Product Change Notification						PCN KM/KMF/CMF/6762	
owner	creation date	release date	released by	change order no	rev	page	D10-063-055
kummerpa	07.02.2022	15.02.2022	muehlema	2023496	A	1 of 2

Product Change Notification					PCN 6762 (snap-in)		
owner	creation date	release date	released by	change order no	rev	page	D10-039-976
huberth	25.09.2019	01.10.2019	limachcl	2018434	A	1 of 1

Old product approval	New product approval

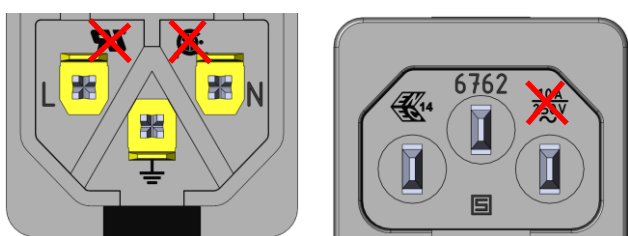
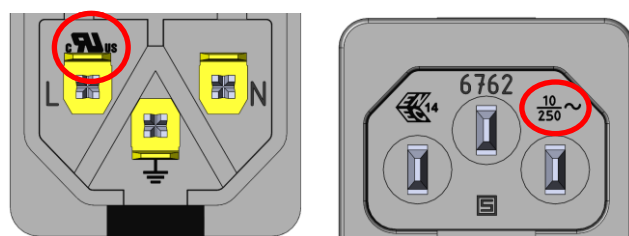
Change of approval markings from UR and CSA to the combined cURus on the product socket.

## 3 Detailed description of change

Form	Yes	Socket new with cURus approval marking
Fit	No	-
Function	No	-
Manufacturing	No	-
Label	No	-
Packaging	No	-
